RECORD PLANS

PROPOSED IMPROVEMENT
 BRIDGE PROJECT

PROJECT NAME: MENDON
 PROJECT NUMBER: BRO 1443(43)

PROJECT NAME:	MENDON	PLOT DATE:	07-SEP-2010
PROJECT NUMBER:	BRO 1443 (43)	DRAWN BY:	G. LAROCHE
FILE NAME:	s01j272xs.dgn	CHECKED BY:	J. SALVATORI
PROJECT LEADER:	K. HIGGINS	SHEET	31 OF 32
DESIGNED BY:	G. LAROCHE		
CHANNEL SECTIONS #1

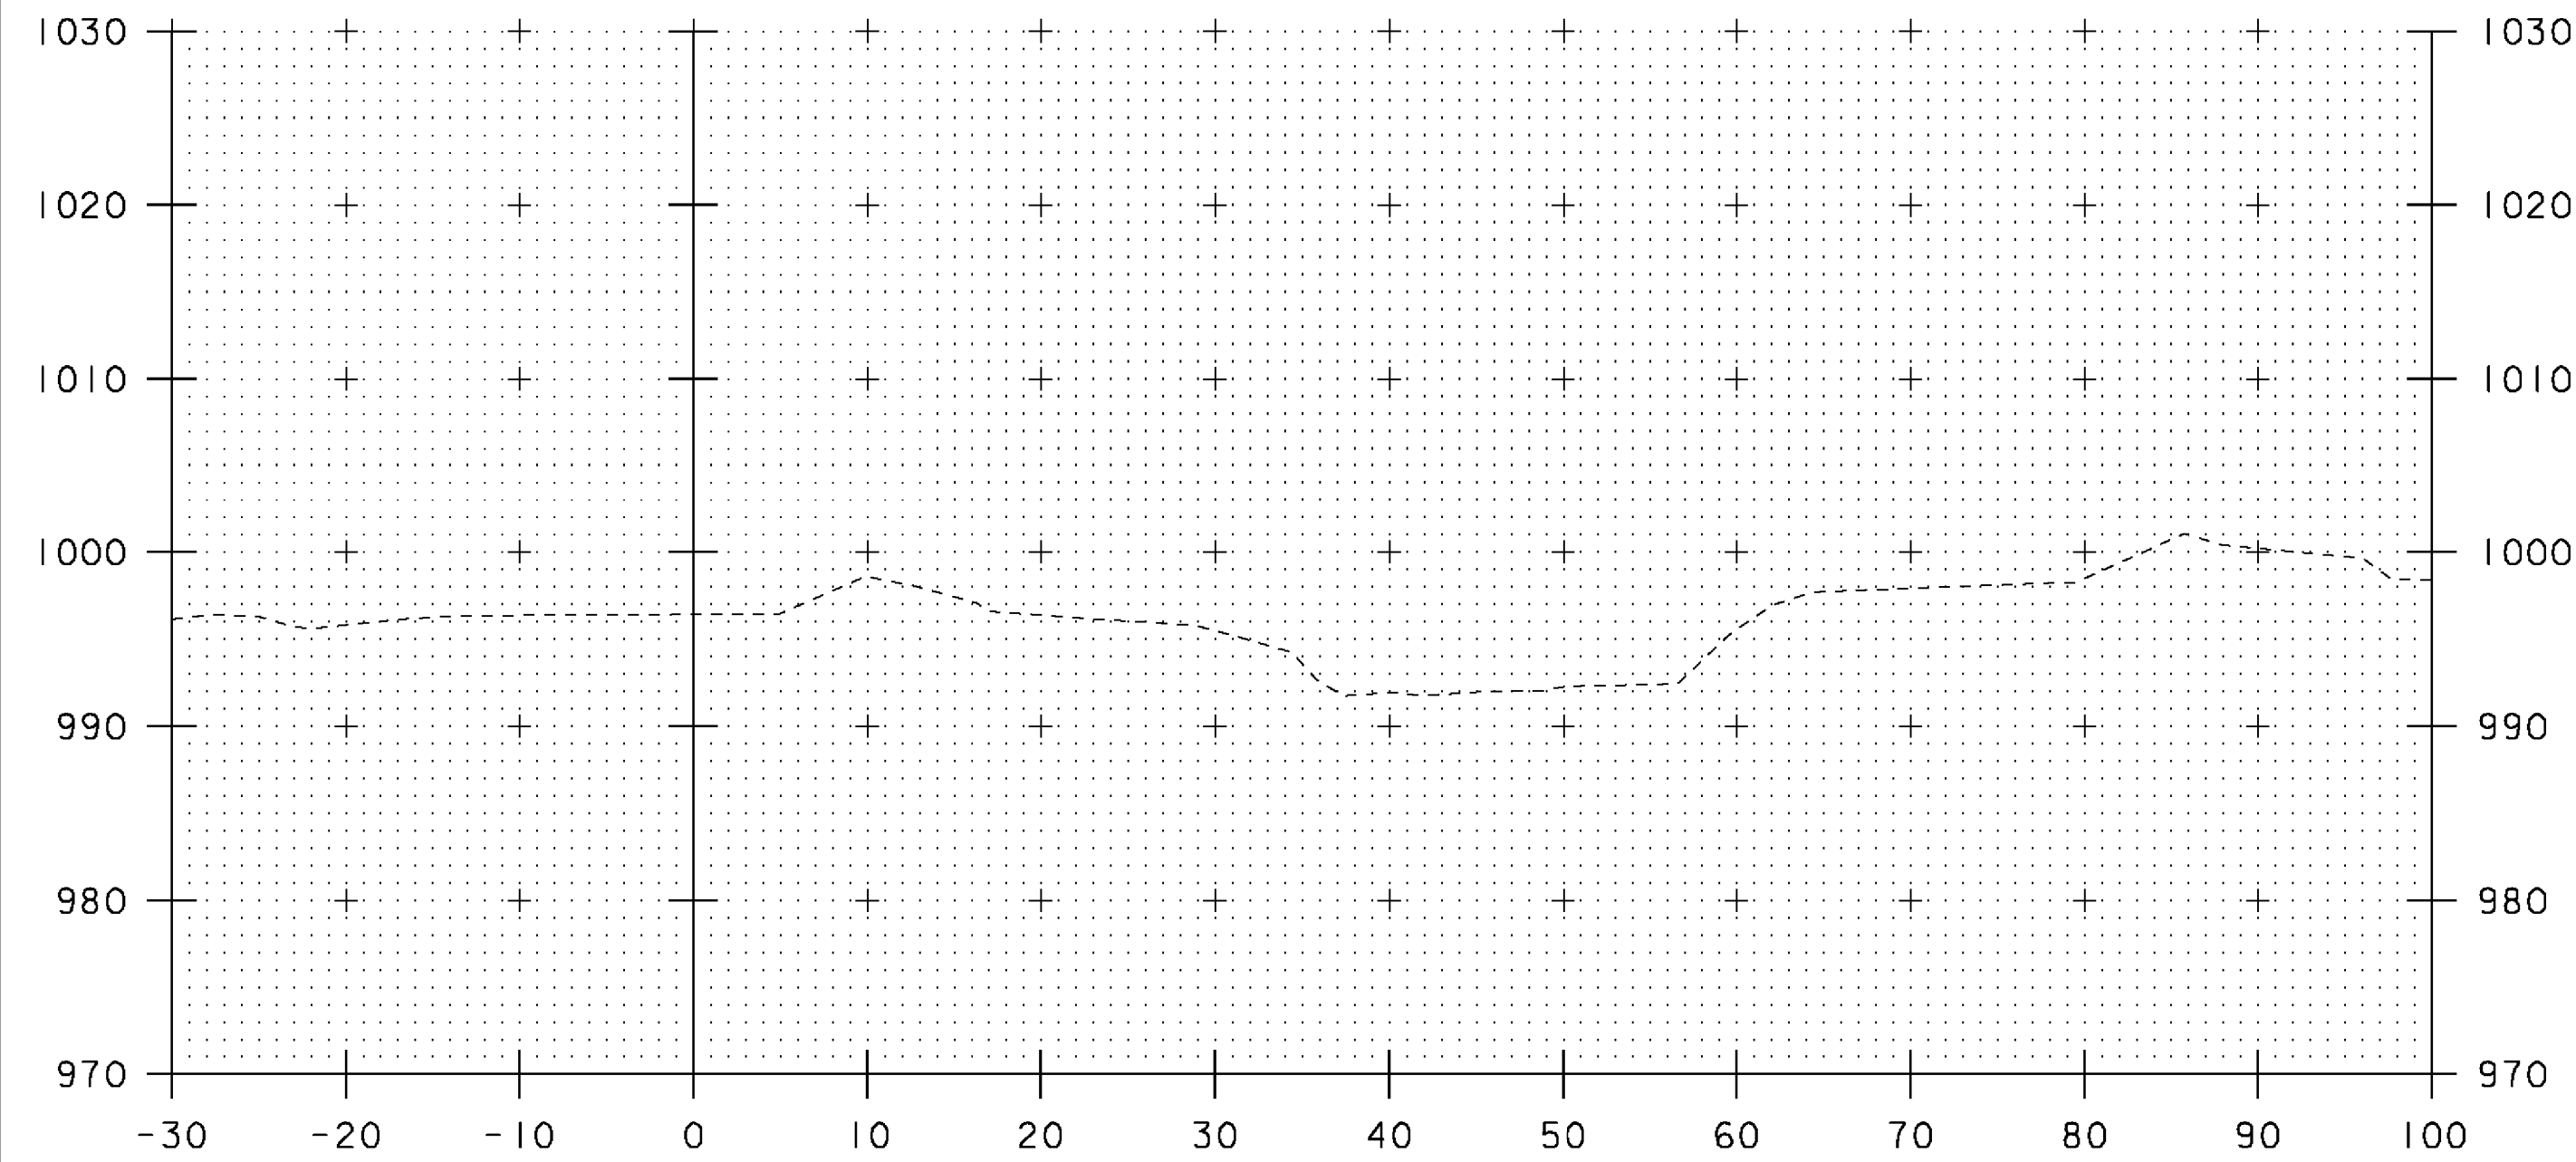
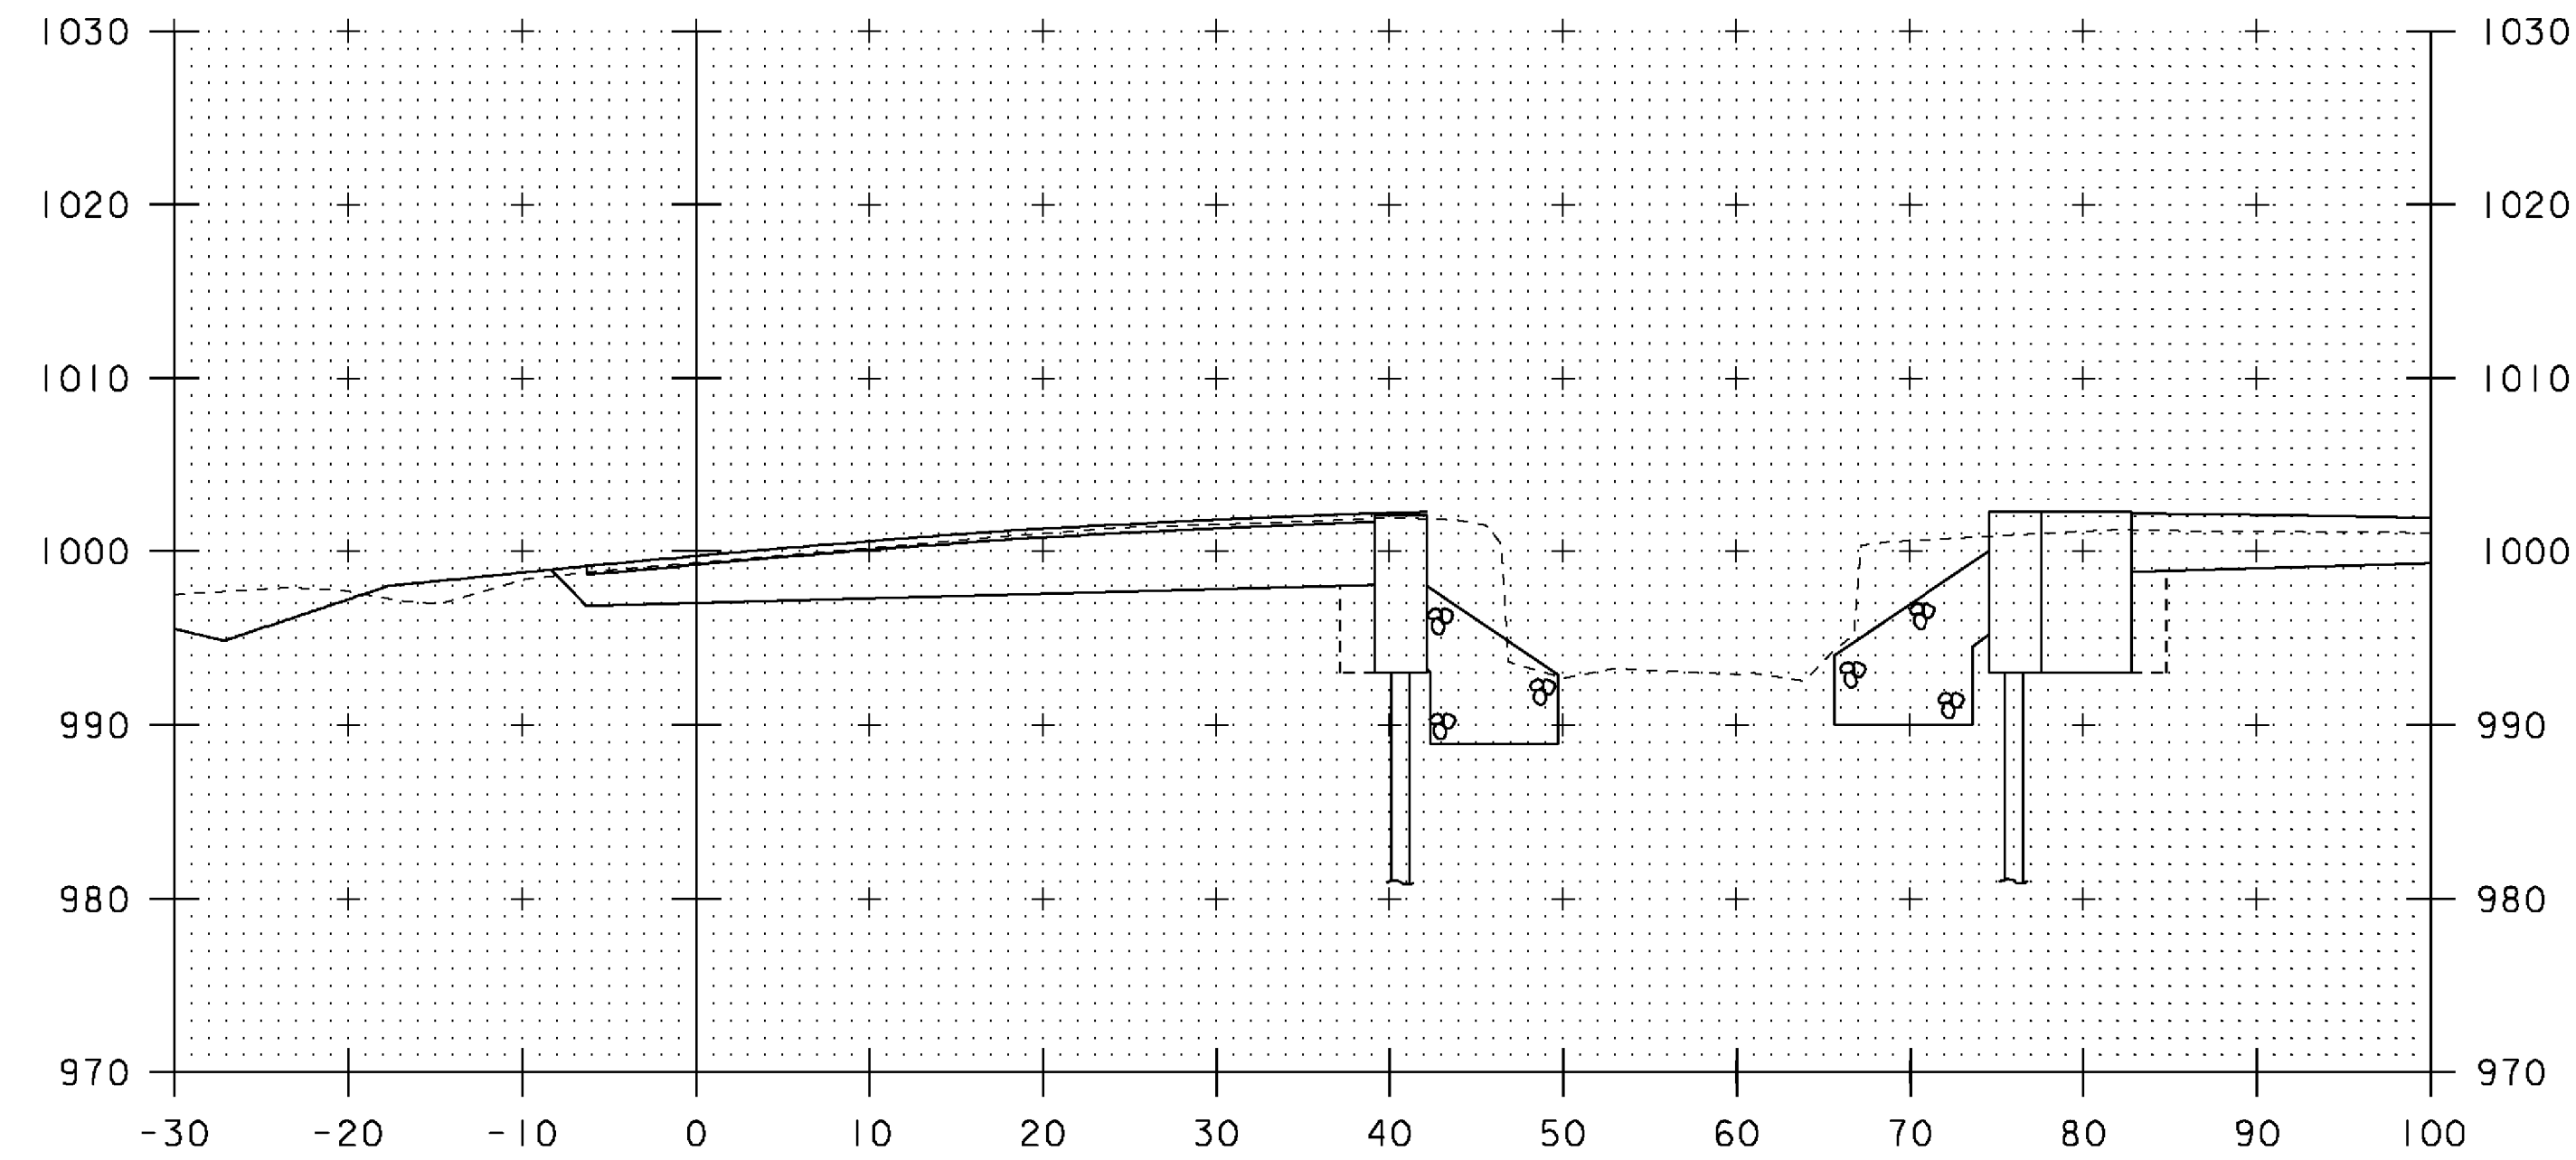
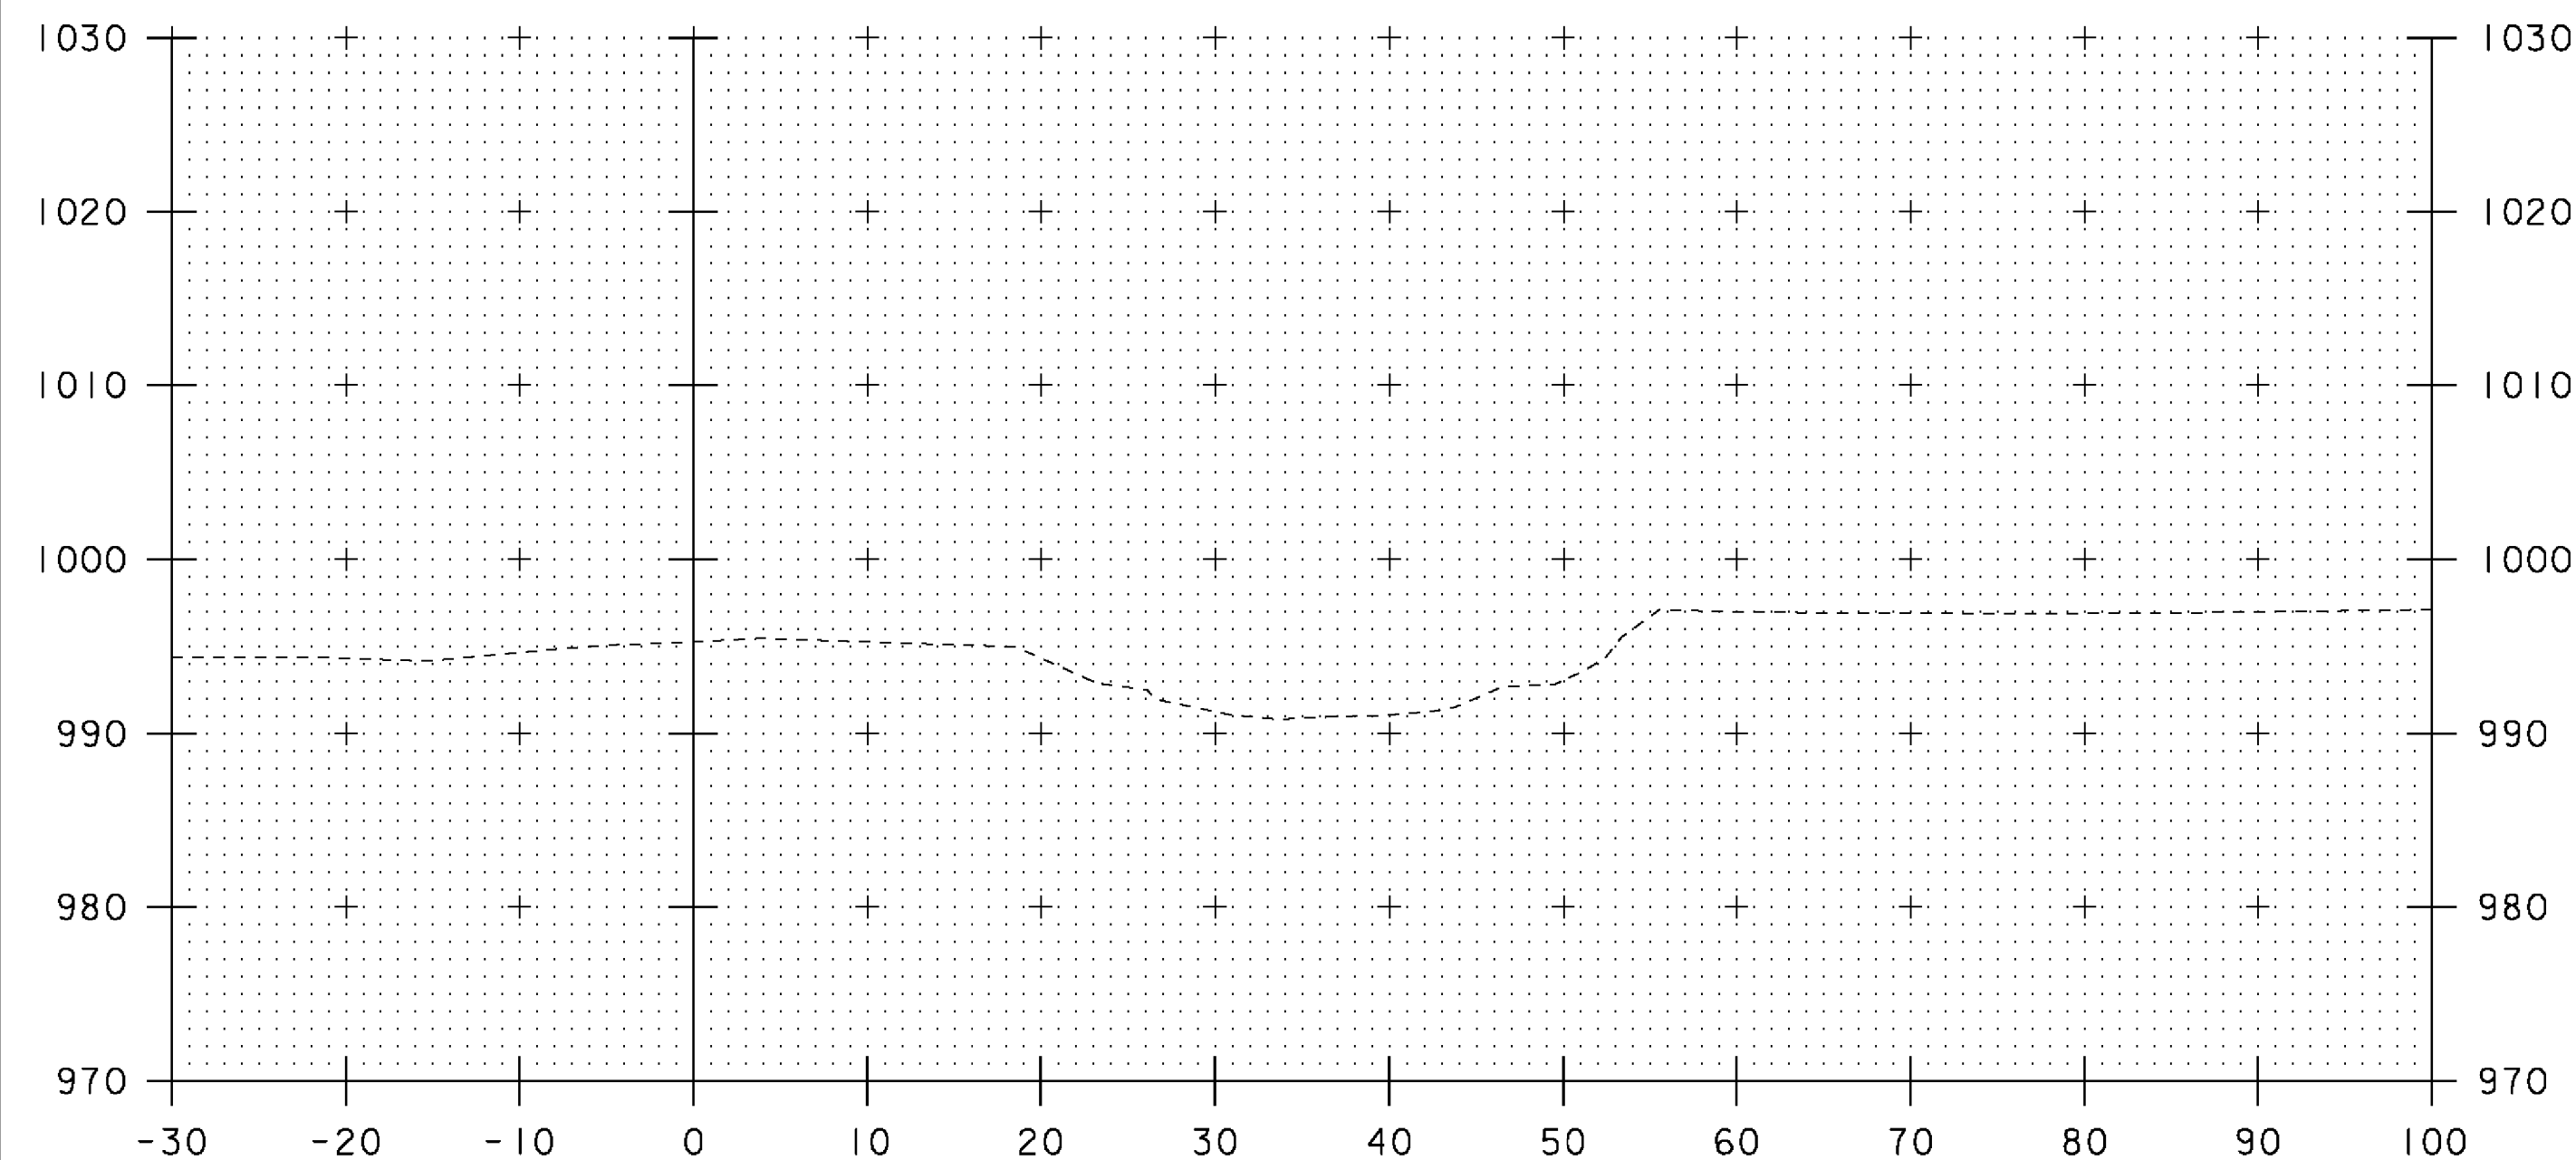
EXISTING GROUND NO LONGER VALID SINCE IRENE 8-28-11.
 NEW SURVEY REQUIRED FOR CHANNEL SECTIONS
 (TYP ALL SHEETS 31 & 32).
